## Solicitation CIP WU-83 12" Waterline Project – Phase 3B ADDENDUM #4

Questions and Answers – BID TAB HAS BEEN REVISED
May 23, 2019

WATER TRENCH DETAIL

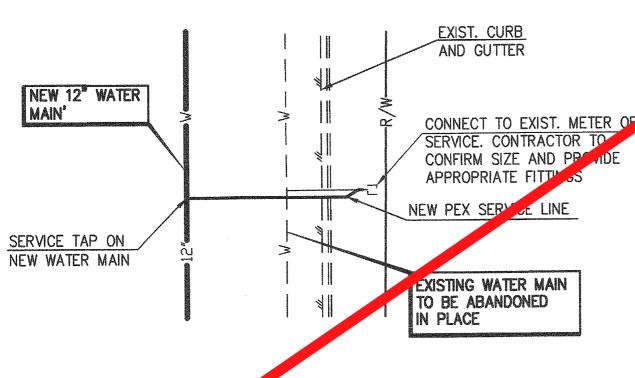
**#7 QUESTION:** 4' "T" top?

**#8 QUESTION:** Is back fill to be native or ABC?

**ANSWER:** Please bid the project as the plans are prepared and details are shown. If there is a need to modify the detail as the project unfolds the Town will process a change order.

**ANSWER:** Please bid the project as the plans are prepared and details are shown. If there is a need to modify the detail as the project unfolds the Town will process a change order.
